Well Name	Well Number	US Well Number	Lease Number	Case Number	Operator
STRANGER 34	302H	3002554237	NMNM113898	NMNM113898	DEVON
STRANGER 34	101H	3002554234	NMNM113898	NMNM113898	DEVON
STRANGER 34	301H	3002554236	NMNM113898	NMNM113898	DEVON

Notice of Intent

Type of Action: APD Change

Procedure Description: Engineering Only - Devon Energy Production Company L.P. respectfully requests the following changes to the approved APD: Offline BOP/Stump testing variance request. Batched wells on STRANGER 34 WELLPAD 4. Please see attached Break Test Variance_Offline BOP variance request document.

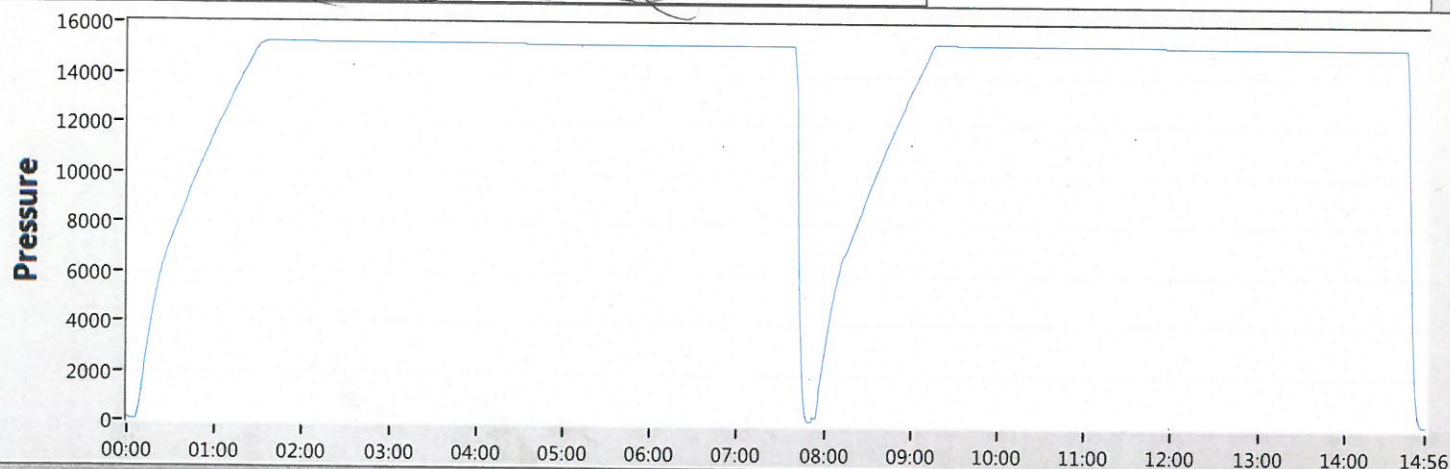
Devon Energy requests to only test BOP connection breaks after drilling out of surface casing and while skidding between wells which conforms to API Standard 53 and industry standards. The initial BOP test will follow 43 CFR 3172, and subsequent tests following a skid will only test connections that are broken. This test will at minimum include the Top Pipe Ram, HCR, Kill Line Check Valve, QDC (quick disconnect to wellhead) and BOP shell of the 10M BOPE to 5M for 10 minutes. Additional pressure testing is required for pressure-containing and pressure-controlling connections when the integrity of a pressure seal is broken. If a break to the flex hose that runs to the choke manifold is required due to repositioning from a skid, the HCR will remain open during the shell test to include that additional break. The variance only pertains to intermediate hole-sections. This variance will meet or exceed 43 CFR 3172 per the following: Devon Energy will perform a full BOP test per 43 CFR 3172 before drilling out of the intermediate casing string(s) and starting the production hole, testing the Annular during initial BOP testing to a minimum of 70% RWP and higher than MASP, and pressure testing at a 21-day interval frequency. The BLM will be contacted 4hrs prior to a BOPE test. The BLM will be notified if and when a well control event is encountered. In the event break testing is not utilized, then a full BOPE test would be conducted.

Devon Energy requests to perform offline BOP stump testing and offline BOPE testing. All pressure-containing and pressure-controlling seals will be tested either online or offline as denoted in the table below and per BLM approval during initial BOP test following test pressure requirements set forth in 43 CFR 3172. Remaining components not tested offline or on the stump will be tested within 72-hours when the BOP is connected to the wellhead. If stump testing exceeds 72-hour window prior to connecting to the wellhead, the BLM will be notified and either stump testing restarted, or the BOP being tested online. The BLM will be contacted 4hrs prior to a BOPE test. The BLM will be notified if and when a well control event is encountered. In the event stump testing is not utilized, then a full BOPE test would be conducted.

Devon requests offline BOPE testing for the following components: Upper Rams, Blind Rams, Kill Valves, Choke Valves, and Annular

Devon requests Break testing as stated above for 5K tests, not including production hole

Annular Preventer will be tested to minimum of 70% RWP and higher than MASP during initial BOP test

All Previous COAs Still Apply. Variance request procedure is approved as written, please see below general conditions for variance.

Operator has been **(Approved)** to test the BOPE offline.

The BOPE offline testing shall be stationary during pressure testing.

Online BOPE testing should commence within 72 hours of offline BOPE testing completion. Notify the BLM if interval exceeds 72 hours.
